DART SERVICE INSTRUCTION

TO AMEND INSTALLATION INSTRUCTIONS IIN-D407-781-1 REV E AND INSTRUCTIONS FOR CONTINUED
AIRWORTHINESS ICA-D407-781 REV 4

REF CANADIAN STC: SH08-60
FAA STC: SR02726NY
EASA STC: EASA.IM.R.S.01541

The purpose of this Dart Service Instruction (DSI) is to provide an alternate method of installing the D206-781-021 Floor Protector Kit when it is installed on aircraft without carpets.

FIGURE 1: FLOOR PROTECTOR INSTALLATION

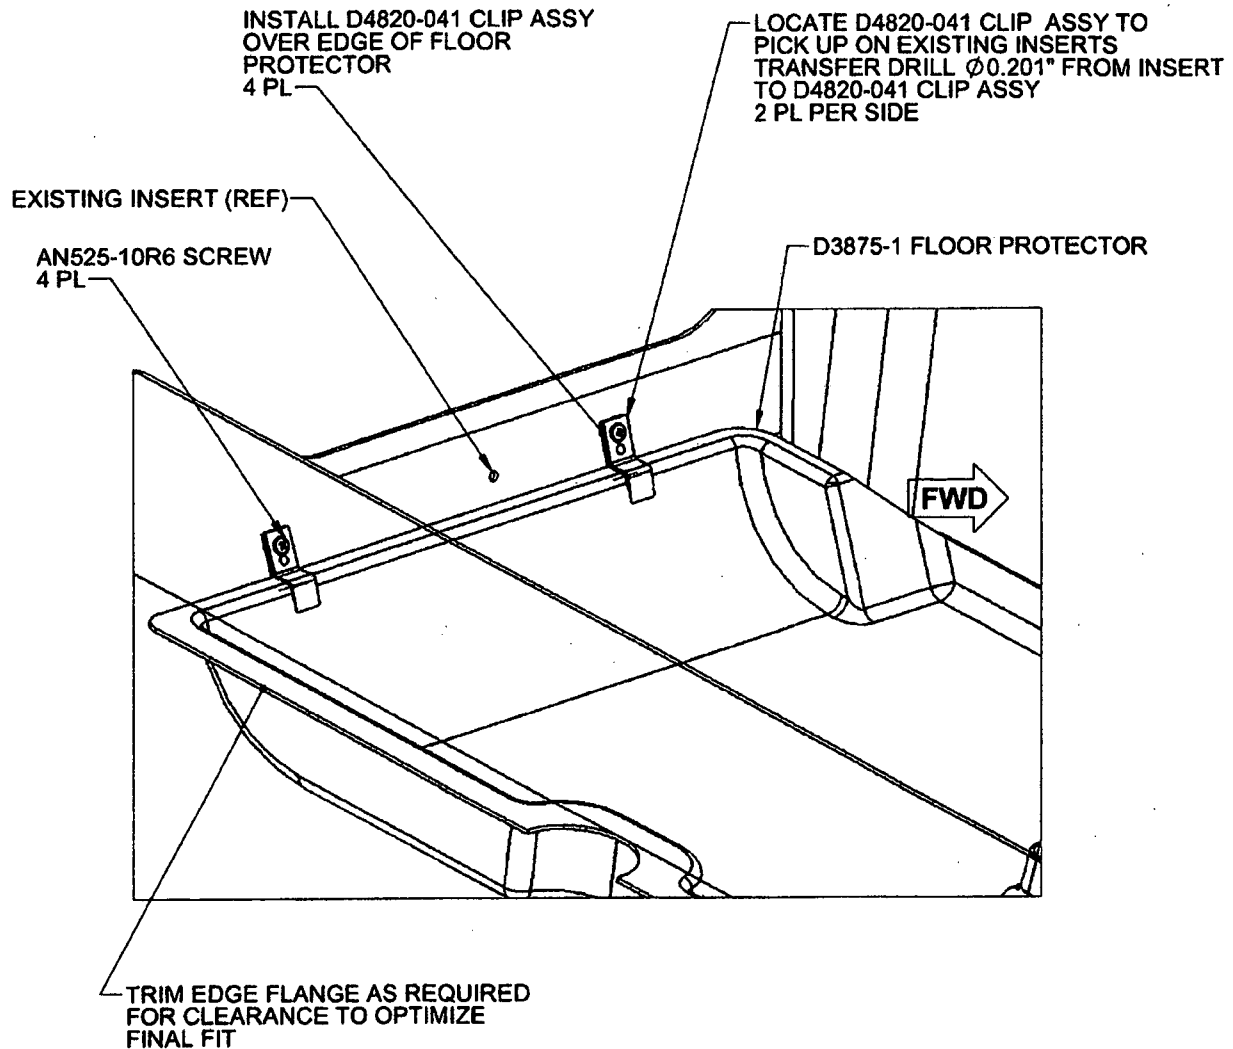
- 2.1 Position the D3875-1 Floor Protector in the passenger area, trimming the edge flanges, as required, for clearance around obstacles and/or to optimize the fit. Ensure there is no debris beneath the protector.

- 2.2 Select the best positions for the D4820-041 Clips to pick up on the existing inserts (2 per side). Press down firmly on the floor protector to ensure it is in full contact with the aircraft floor and transfer mark the hole locations to the D4820-041 Clips.

- 2.3 Drill out the marked holes to $\varnothing 0.201$ and deburr.
- 2.4 Install the D4820-041 Clips (2 per side) using AN525-10R6 screws and secure the D3875-1 Floor Protector. The flat portion of the D4820-041 Clip Assy should slip behind the D3875-1 Floor Protector. Torque the screws to 15-25 in-lbs (1.7-2.8 N-m).

Qty -021	Part Number	Description
X	D206-781-021	FLOOR PROTECTOR KIT (PASSENGER CABIN)
1	D3875-1	FLOOR PROTECTOR, PASSENGER
2	D3934-041	CLIP ASSY
4	D4820-041	CLIP ASSY
4	AN525-10R6	SCREW
2	D3800-1-100-500	LOOP STRIP
2	D3800-3-100-500	HOOK STRIP

Qty -021	Part Number	Description
X	D206-781-021	FLOOR PROTECTOR KIT (PASSENGER CABIN)
1	D3875-1	FLOOR PROTECTOR, PASSENGER
2	D3934-041	CLIP ASSY
2	AN525-10R6	SCREW
2	D3800-1-100-500	LOOP STRIP
2	D3800-3-100-500	HOOK STRIP
